Square Apparels Limited.

Mamarishpur, Mallikbari, Bhaluka, Mymensingh
(24.27937, 90.36931)

06 June 2022

Observations

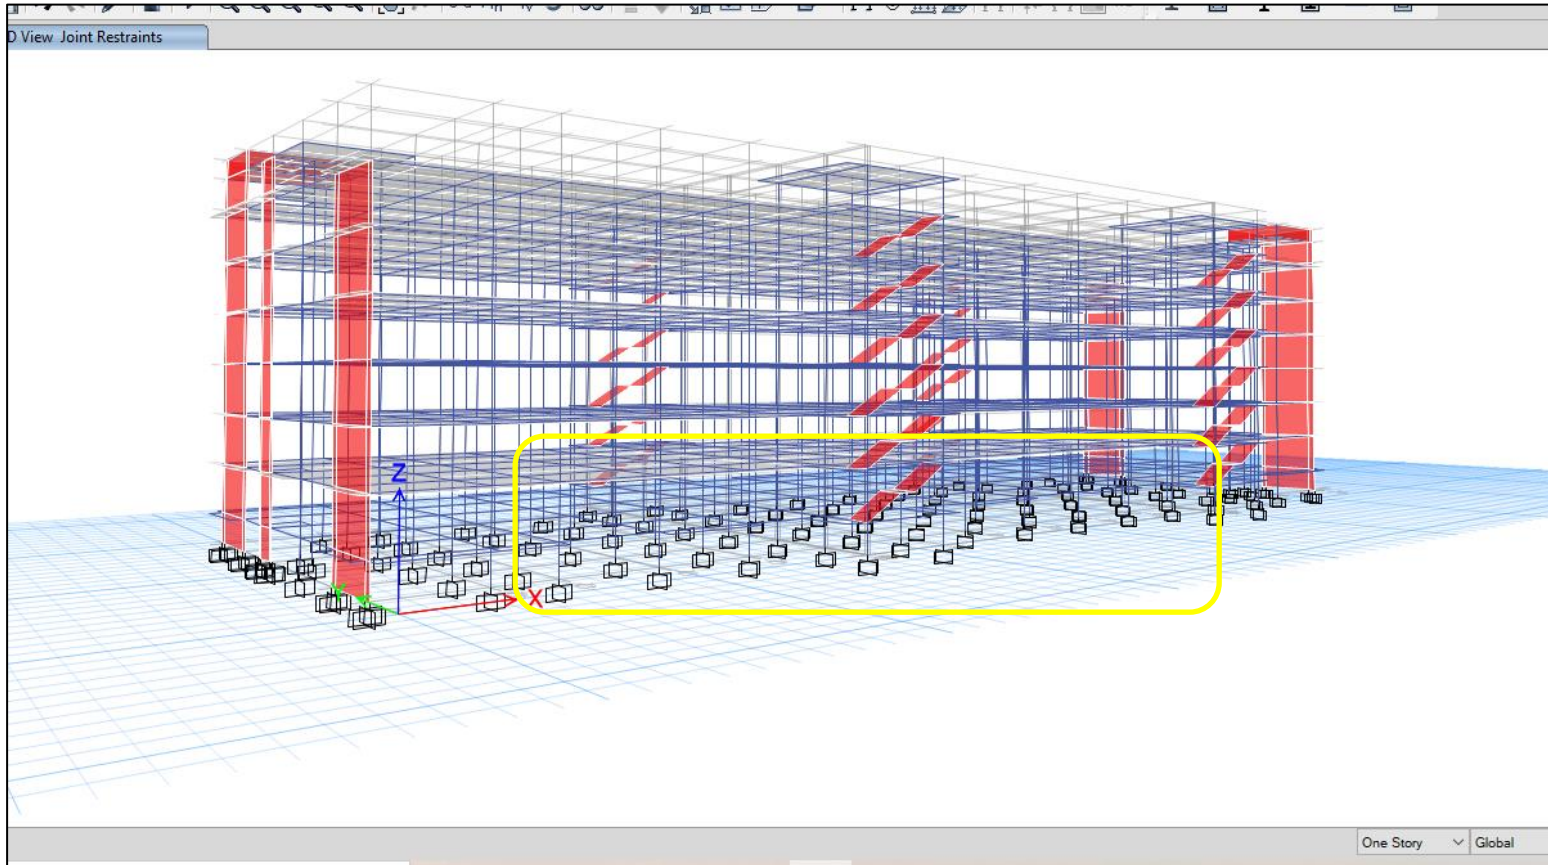
Response modification factor R-value has been assumed as 12 which is referred to Special Moment Resisting Frame (SMRF), but no seismic detailing was provided with the report. Moreover, wind and earthquake load calculations were not included in the report.

Foundation system of the building

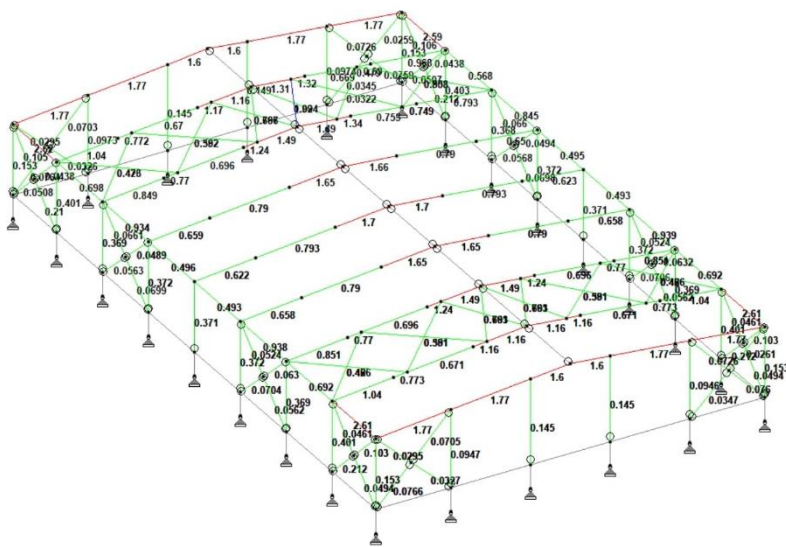
Foundation system of the building is single footings which are rested on compressible soil but fixed support at the end of R.C.C columns have been assigned in the FEA model. Factory engineer is required to review the support system of the foundation.

Fig: RCC Column and Grade

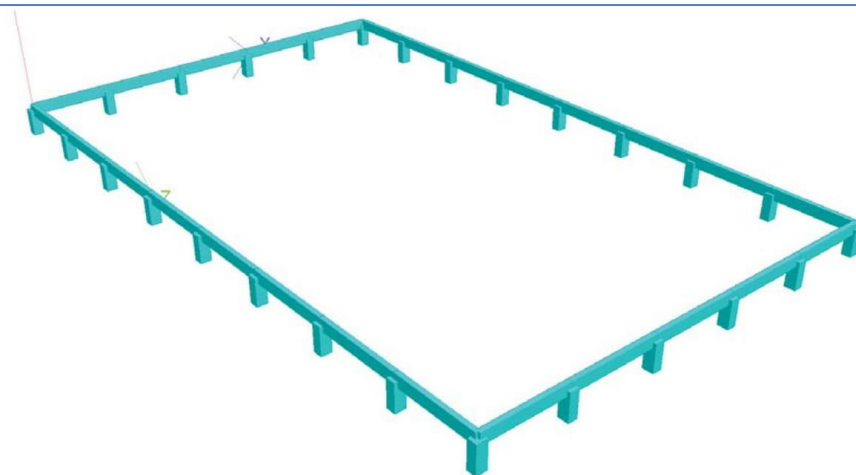
In DEA report, overstress has been found in steel members. Also, it has been noted that pedestal RC columns of the building are inadequate. Remedial actions has not been carried out as per recommendation of DEA report.

Corrosion in steel column (Canopy)

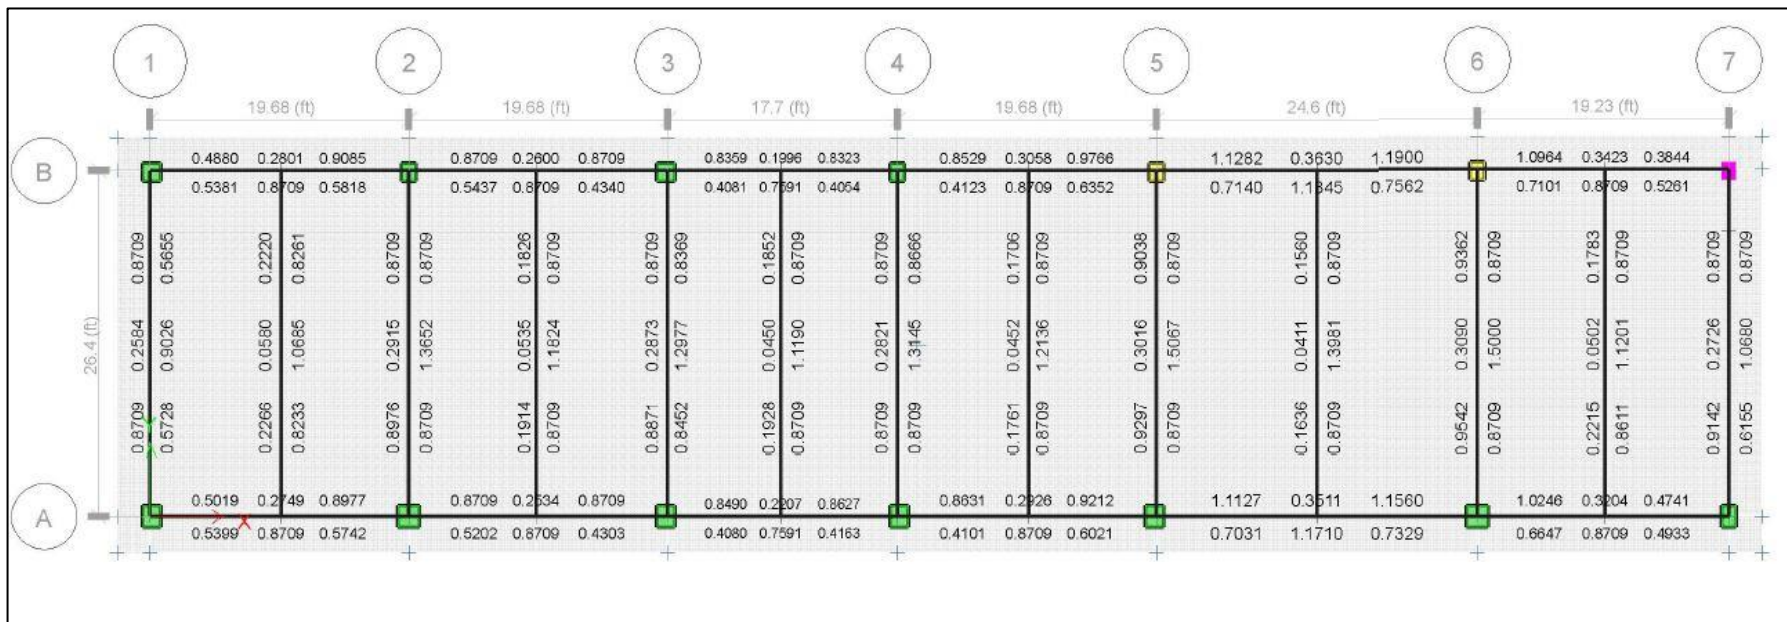
During inspection corrosion was found in steel column & rafter. Factory is required to take proper remedial measures for preventing the corrosion from steel members.

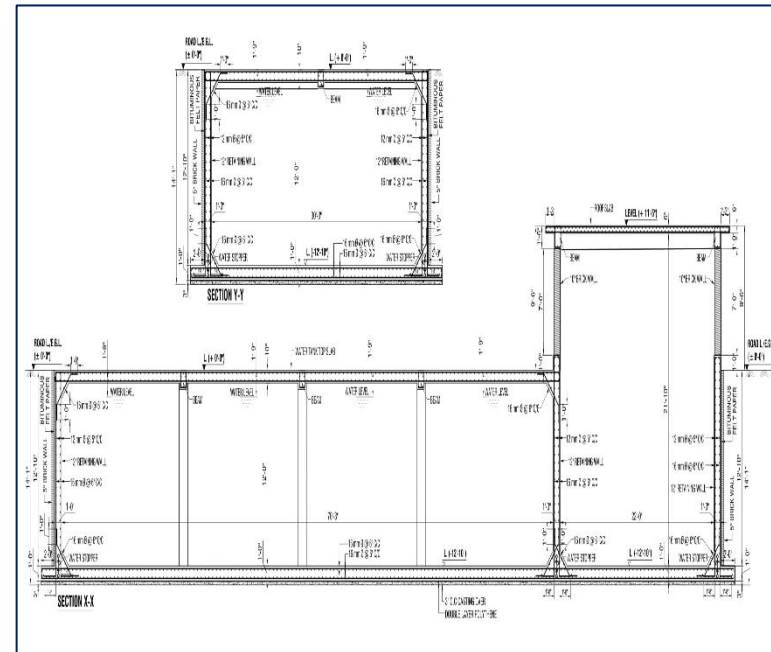
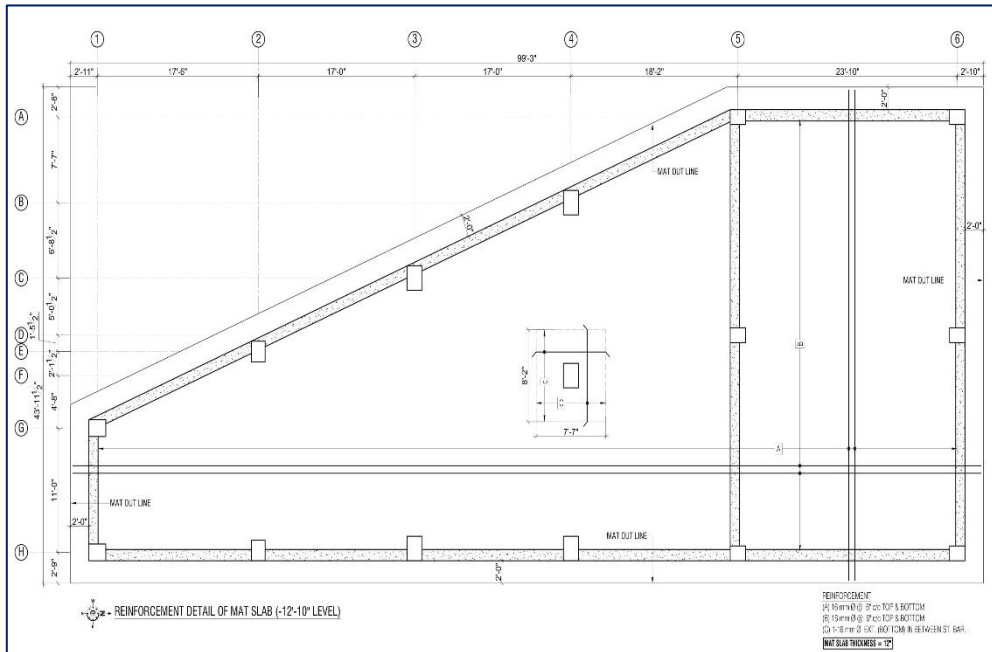
Design report was available on site for Building-5. In which concrete compressive strength f_c' was considered 3500 psi but no material test report was found for justifying the strength.

Building engineer is required to confirm the design concrete compressive strength.

Water Ponding on Roof

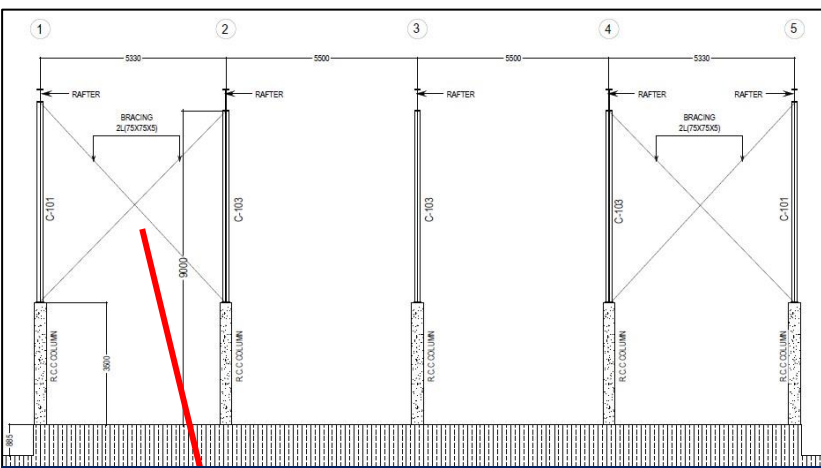
Water ponding was found at roof of the pump house building. During inspection sign of water clogging & dampness at slab soffit was found. Factory is required to improve water drainage system to avoid water clogging at roof.

Bracing Layout plan (elevation)

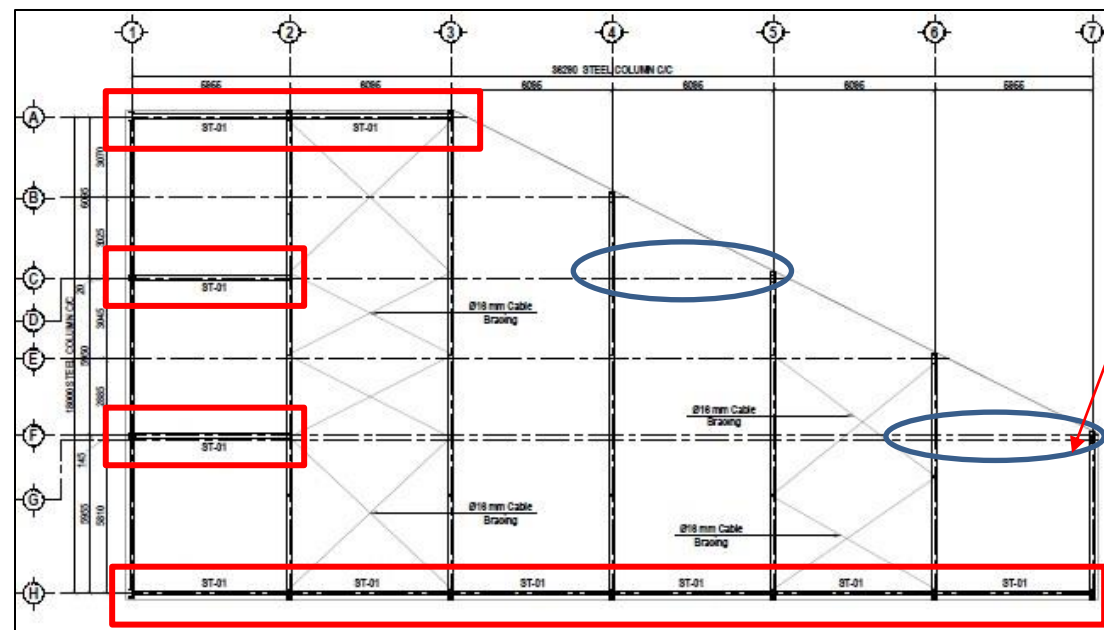
Lateral load transfer media missing at roof level

Tension/Angle bracing without compression strut

Lateral load transfer media (compression strut) along the long direction is missing. Building engineer to check the lateral stability of the structure.
